September 22, 2025

Re: Application for Capital Expenditures for the Life Extension of Bay d'Espoir Unit 7 – Request for Additional Information – Hydro's Reply

Bay d'Espoir Unit 7 Additional Analysis Report

Figure 1: Comparison of Turbine Efficiency Curves

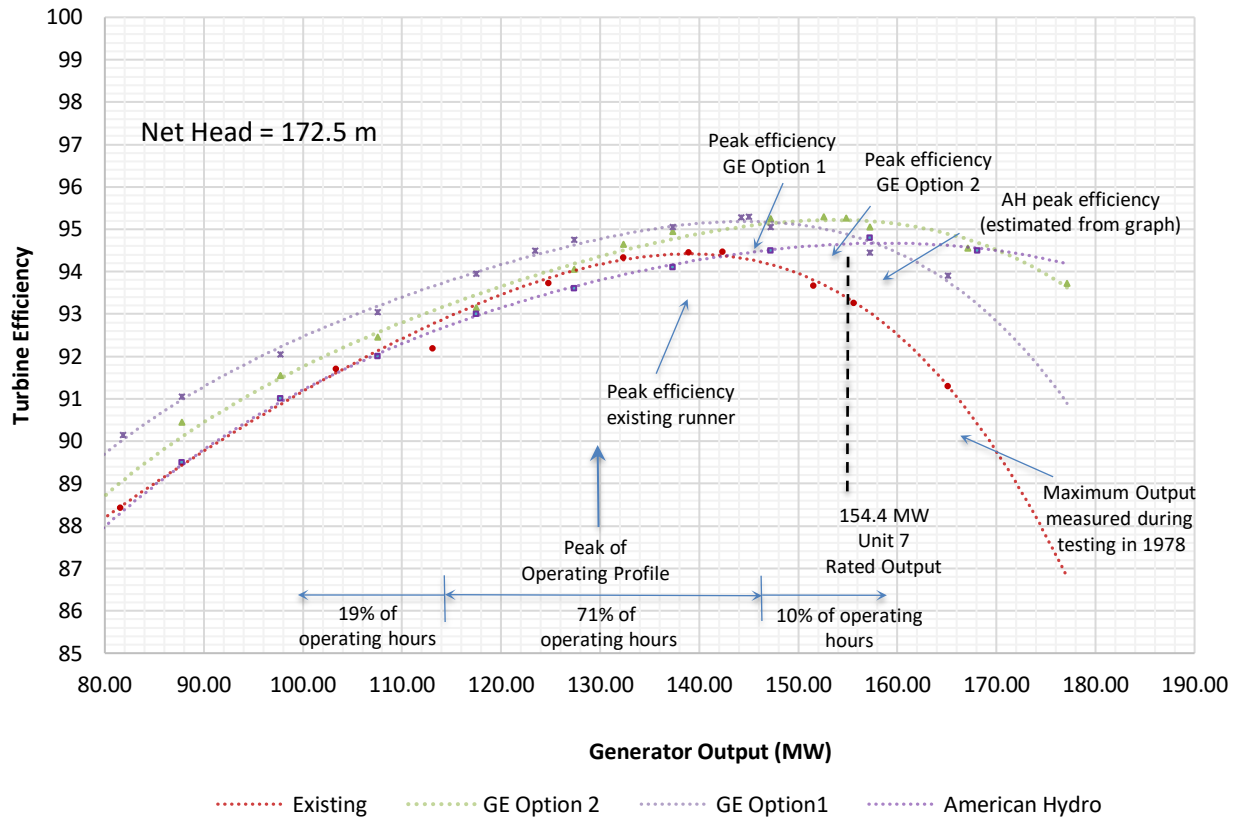
6 The rated output of Unit 7 is shown in Figure 1 as 154.4 MW and represents the maximum continuous
 7 rating of the unit. The unit rating is limited by the ratings of the generator and transformer, both are
 8 172 MVA at 0.9 pf. The unit has been operated above its rating for short durations during testing at
 9 outputs up to 165 MW.

Figure 1

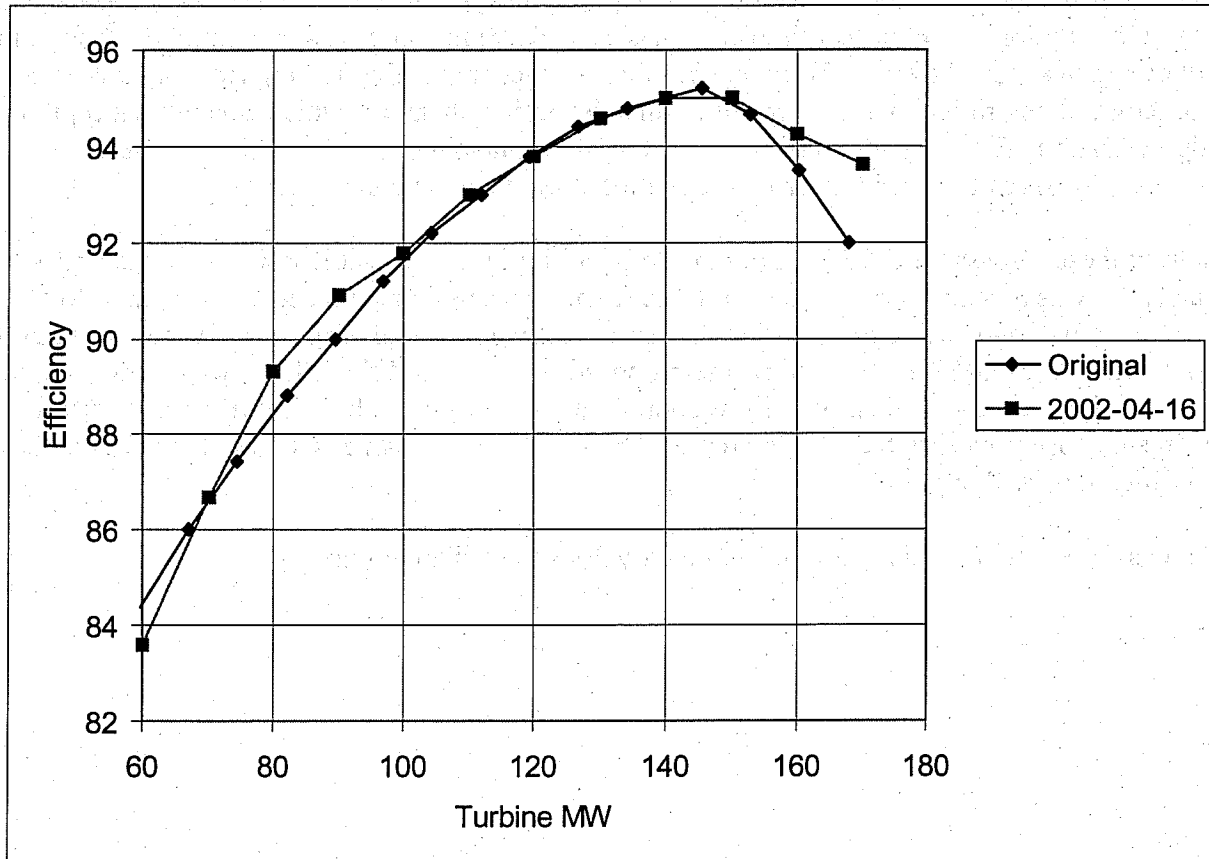
This proposal was dated 2002-04-16. The performance curve for this runner is presented in Figure 1. It indicates a slight increase in capacity (about 2.2 MW) and a slight increase in

efficiency between 70 and 100 MW and above 150 MW. (The “Original” performance curve was obtained from the Dominion Engineering Works proposal for unit 7. It has not been verified by field testing.) GE Hydro prepared the new performance estimates based on a tail water elevation of 0.61 m, which is lower than generally encountered at Bay D’Espoir. GE Hydro was informed that, based on a review of several years of operating data, the minimum, average and maximum tail water elevations are 0.8, 2.2 and 3.2 m, respectively. GE Hydro reconsidered the performance predictions made and responded with a second proposal.

Figure 2

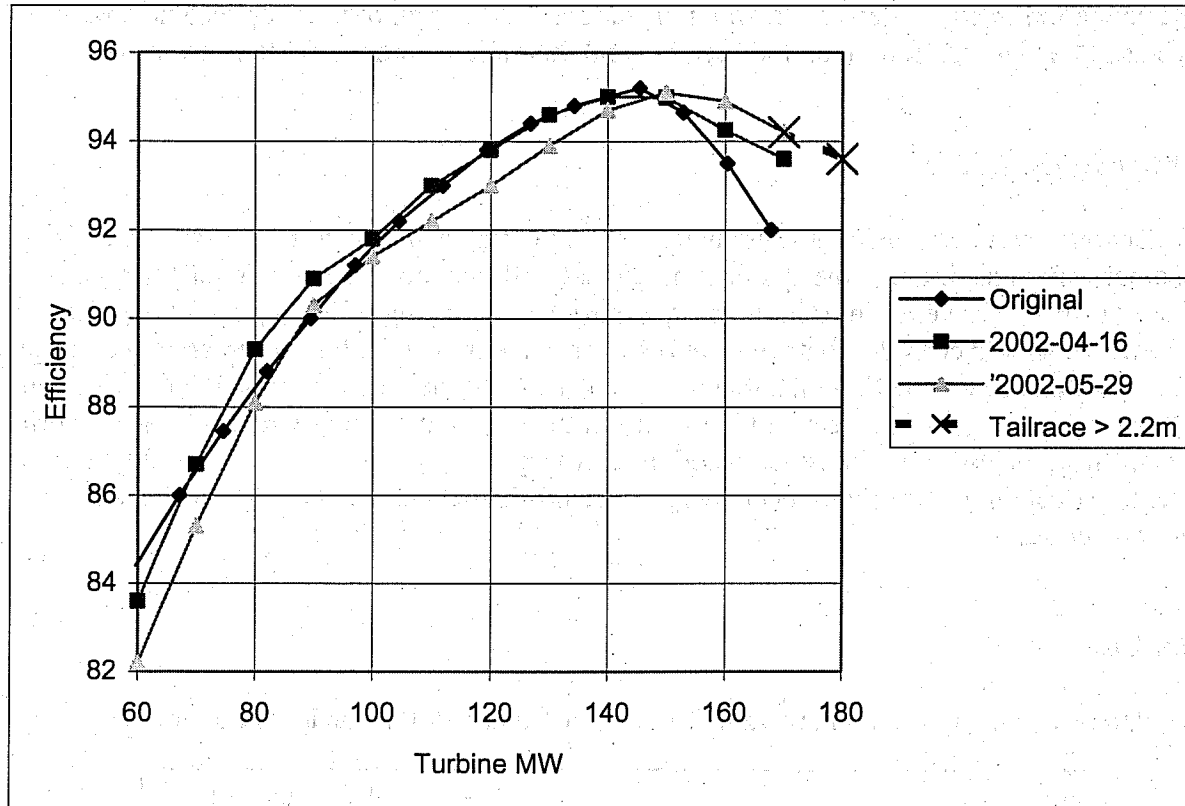
This proposal was dated 2002-05-29. The performance curve for this runner is shown in Figure 2. It indicates that GE Hydro had revised their original proposal to accentuate increased capacity and efficiency at high output.

The curve has the same shape as the 2002-04-16 proposal but has been shifted to the right. Note also the section of this curve to the extreme right which has been identified as "Tailrace > 2.2m". GE Hydro has offered a runner which can produce significantly more MWs, depending on tail water elevation, as shown in Table 1.

Figure 3

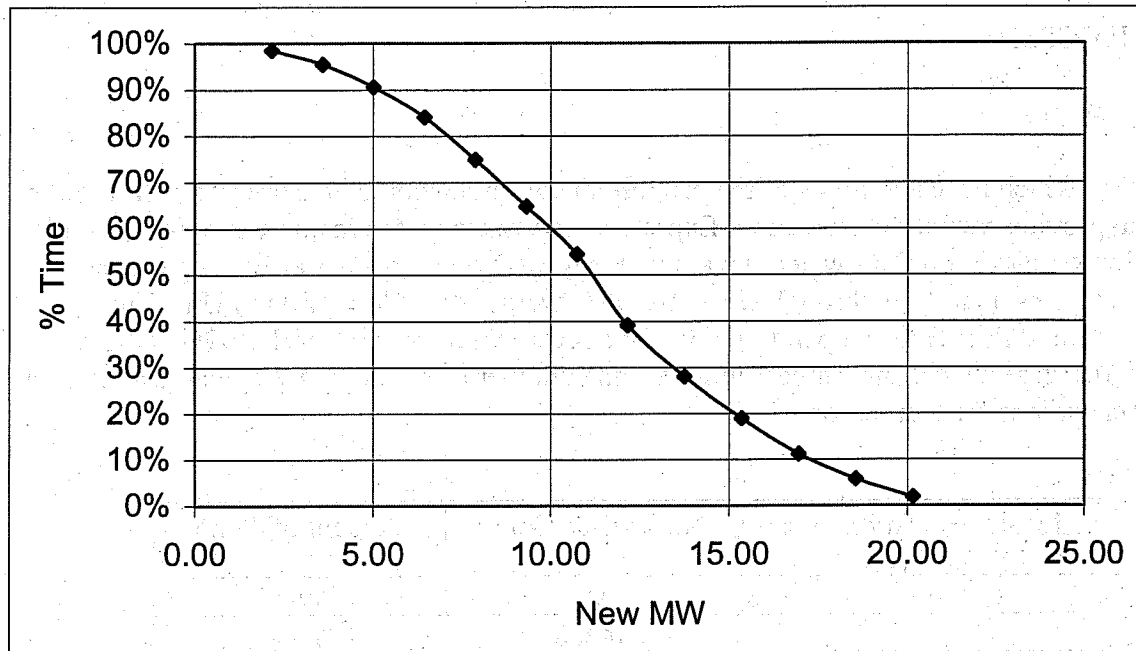
From this data a tail water elevation duration curve was plotted, to indicate how the additional capacity offered by the proposed new runner is limited by tail water elevation. This is presented in Figure 3

As an illustration of the significance of this curve, what it indicates is that we could make use of 15 additional MW of capacity only 20% of the time and 5 additional MW of capacity 90% of the time. The limitations inherent in the design of the proposed runner are apparent from this curve, especially when one considers that high tide will not necessarily coincide with system peak, which is when the additional capacity offered by the proposed runner would be of most use. Similarly, a coincidence of the required maximum output from Unit 7 with high flow rates through Units 1-6 may not occur, limiting the usefulness of the increased capacity. There is additional energy associated with this new runner in that its slight improvement in efficiency at the lower part of mid range and at the high range would improve energy production. However, as operating data indicates that Unit 7 operates only 5% of the time in this range, the energy gained through efficiency improvement would be negligible. As Unit 7 runner has not exhibited any significant corrosion, erosion or cavitation problems, there is no financial benefit to be gained by replacing the runner to address such issues.
